***Rezoning #2014-0013, Development Special Use Permit
#2014-0026, Encroachment #2014-0006
0 Prince Street, 200 & 204 Strand Street – Old Dominion
Boat Club***

Application	General Data	
Project Name: Old Dominion Boat Club	PC Hearing:	March 3, 2015
	CC Hearing:	March 14, 2015
	If approved, DSUP Expiration:	March 14, 2018
	Plan Acreage:	0.419 (18,251 SF)
Location: 0 Prince Street, 200 Strand and part of 204 Strand	Zone:	Existing: W-1 Proposed: WPR
	Proposed Use:	Boat Club
	Dwelling Units:	N/A
	Gross Floor Area:	15, 047 SF
Applicant: Old Dominion Boat Club Represented by Mary Catherine Gibbs, Attorney	Small Area Plan:	Old Town/Waterfront
	Historic District:	Old and Historic Alexandria
	Green Building:	N/A

The applicant requests approval of a Rezoning/Map Amendment from W-1 to WPR, with proffer, an encroachment into the right-of-way, and Development Special Use Permit with modifications, to construct and operate a boat club building, and a Special Use Permit for a parking reduction.

Exhibit 2: Tree well design for Strand Street shall include the following amendments:

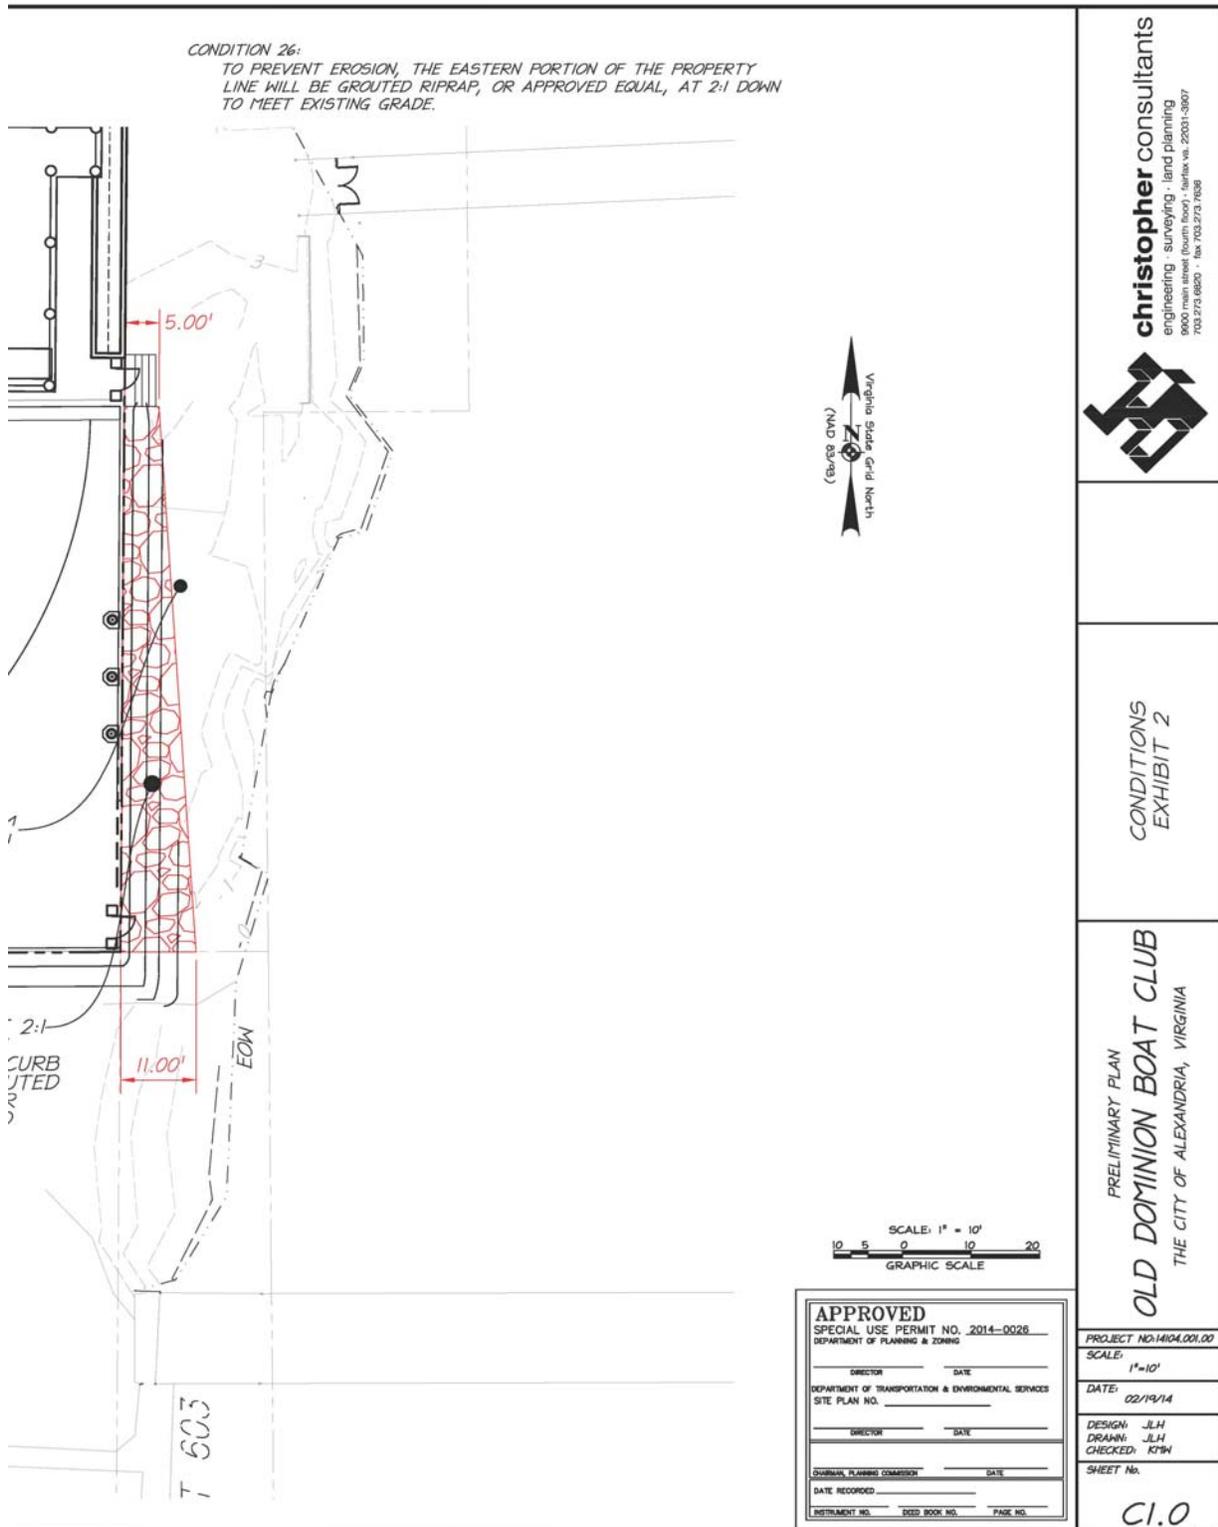
- 1) reduce the depressed soil level to that of a standard tree well with grate, and
- 2) remove the curbside inlet
